PUMPHOUSE REVISIONS FOR IRON REMOVAL PLANT

MICHIGAN
DEPARTMENT OF CONSERVATION
PARKS AND RECREATION DIVISION

TAHQUAMENON FALLS STATE PARK
LOWER FALLS CAMPGROUND WATER SYSTEM
Scale 3/4" = 1'-0"

PLAN NO.
E-110 A

SECTION A-A

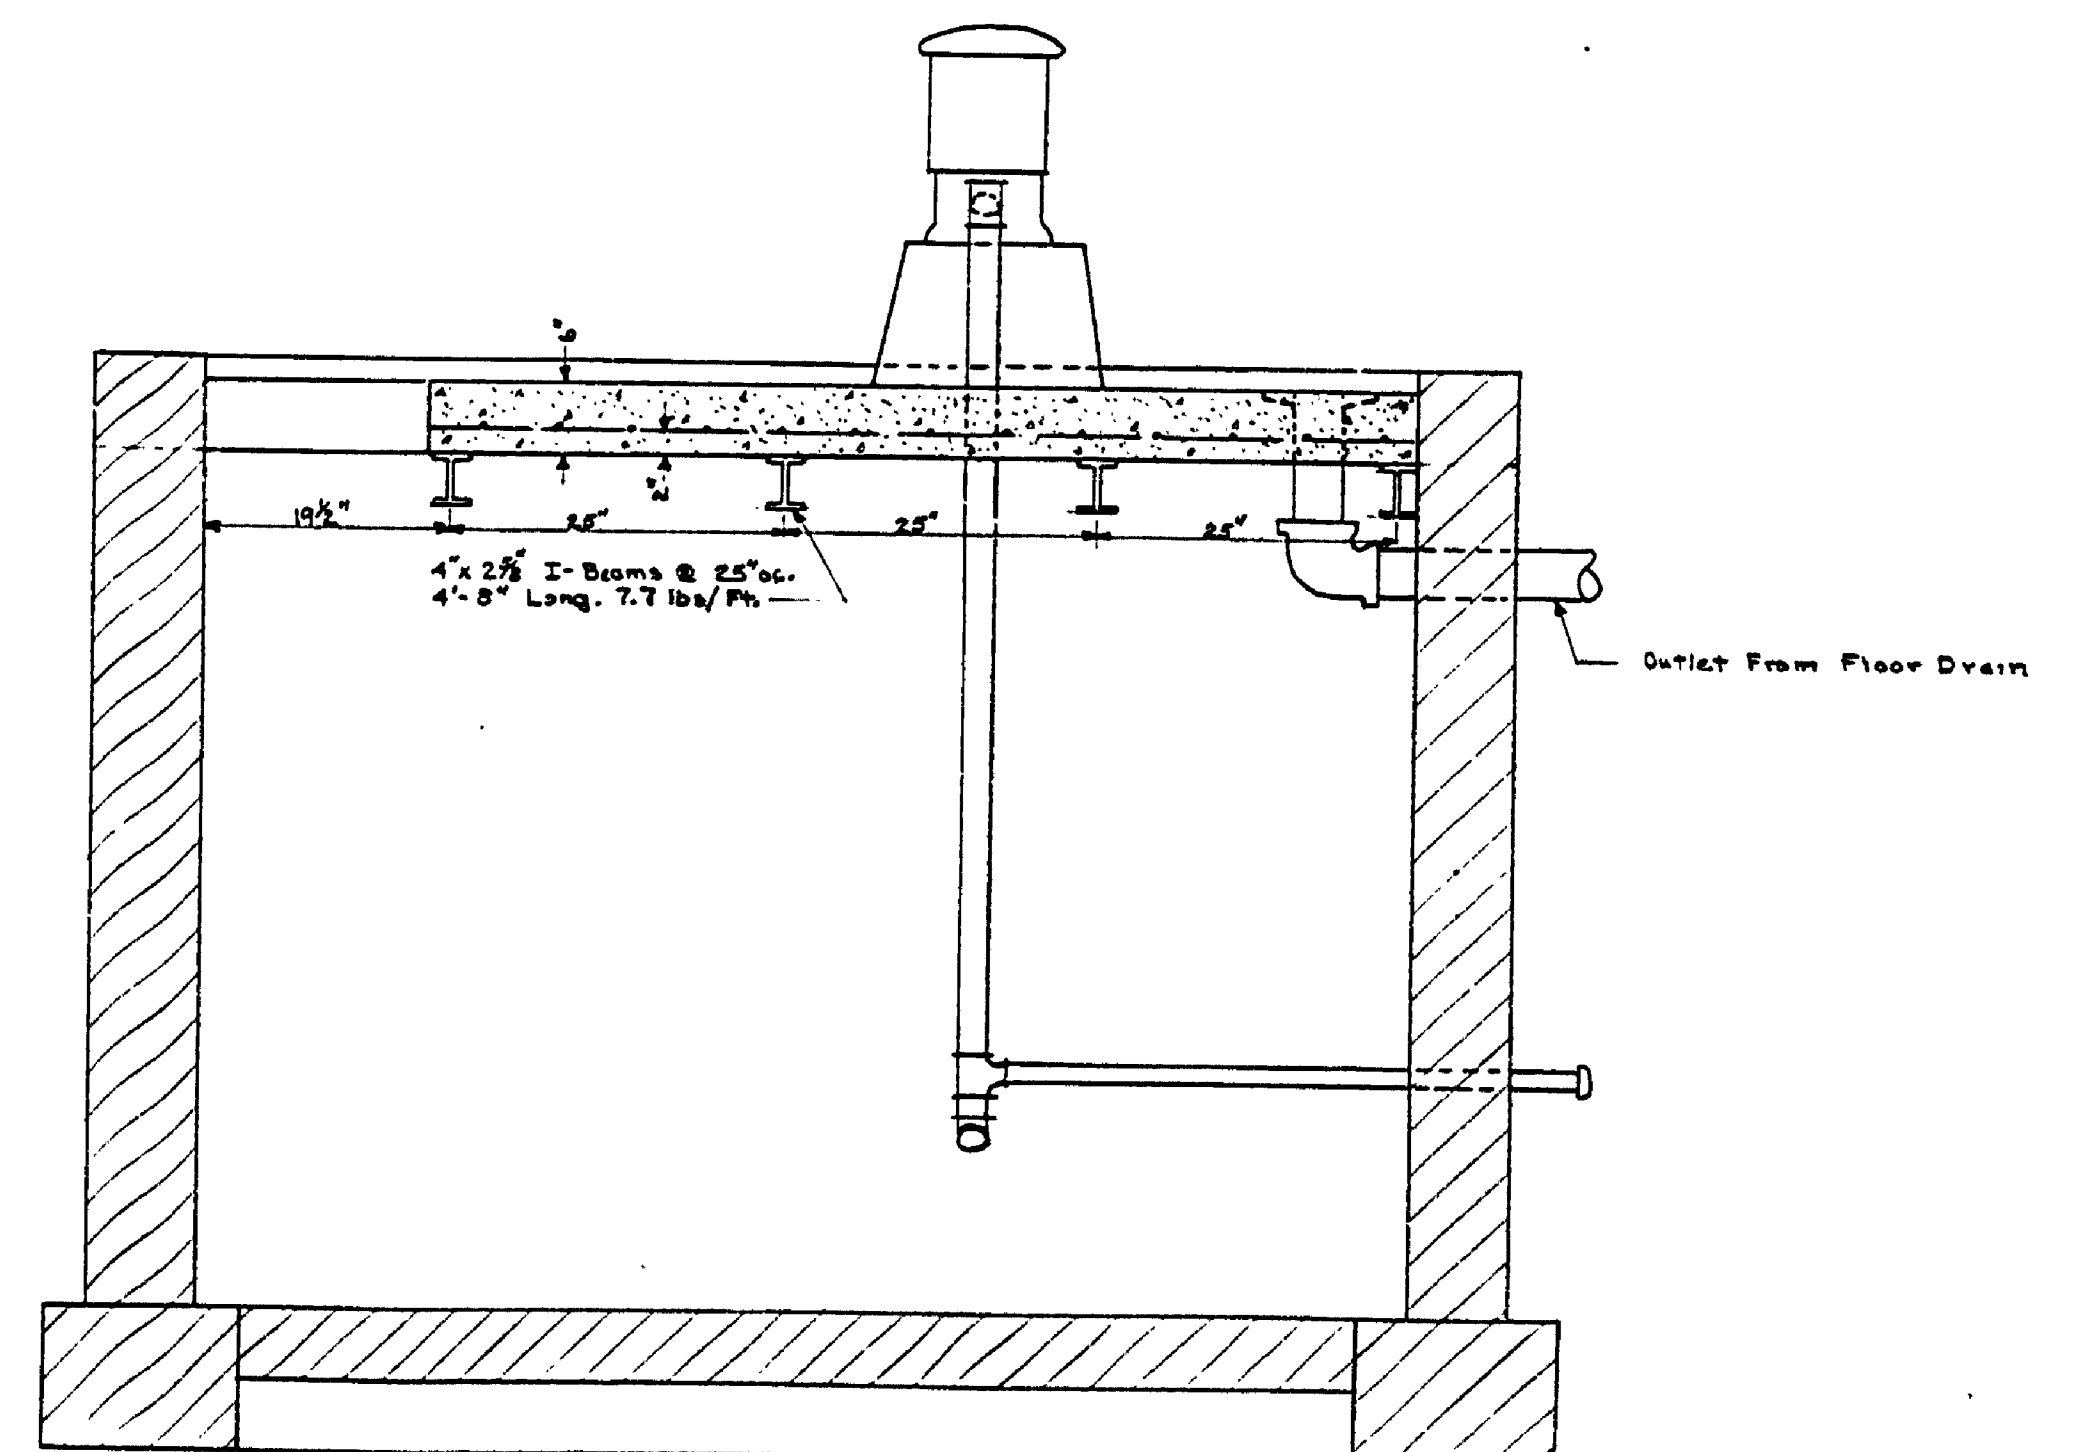
- Notes:
1. Revise Piping 2" Tees & 1-2" Gate Valve As Shown
 2. Break Old Floor Back About 6" The Total Length Of The Pump Pit.
 3. Break Out The Blocks Necessary To Set I-Beams As Shown
 4. Fill Blocks Below I-Beams With Concrete For Better Bearing
 5. Set I-Beams And Grout In With Concrete
 6. Do NOT Pour Floor Until Grout Around I-Beams Is Well Cured
 7. Be Sure Floor Drain is Set Before Pouring Floor
